**Residential subdivision and development in coastal wetlands area
43, 45 and 49 Warriewood Road, Warriewood (Lot 2 DP 972209, Lots 1 and 2 DP 349085)
Planning Secretary's Environmental Assessment Requirements (SEAR) 1457**

I refer to your request for a review of and advice on the SEAR and TfNSW requirements related to the traffic and parking. My advice is as follows.

Figure 1. Common routes for road transport from the site in all directions (source: Google maps).

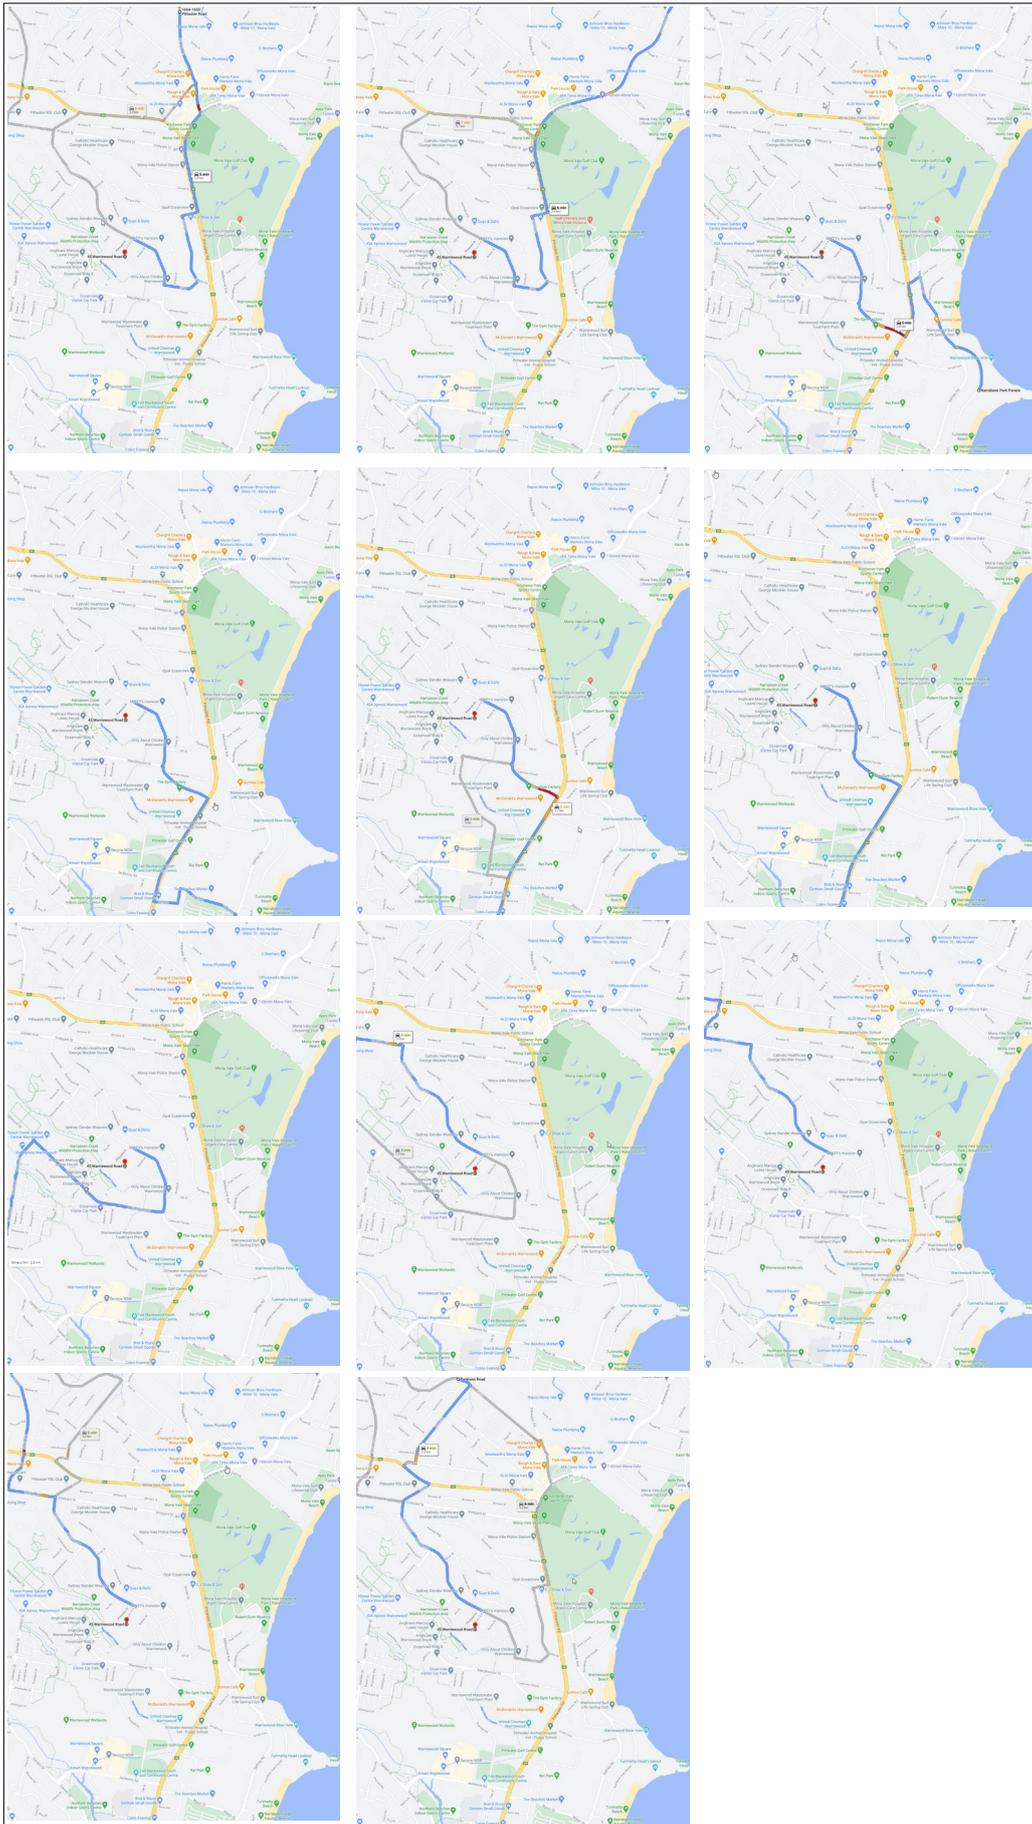
- **SEAR requirement 1.**
 - details of road transport routes and access to the site
 - road traffic predictions for the development during construction and operation, including the impact on the nearby intersection of Warriewood and Pittwater roads

- Most common road transport routes, as determined using Google maps travel guidance feature, are shown in Figure 1 attached to this letter.
 - Traffic predictions during operation were detailed in the Traffic and Parking Impacts Assessment (TPIA) report. The number of trips for morning and afternoon commuter peak hours were calculated as 18 and 11 trips per hour respectively (in and out combined), using TfNSW (RMS) Guide trips rates. It was concluded in the TPIA that the estimated additional number of vehicular trips was too low to have any effect on the operation of the road network generally and on the critical intersections specifically.
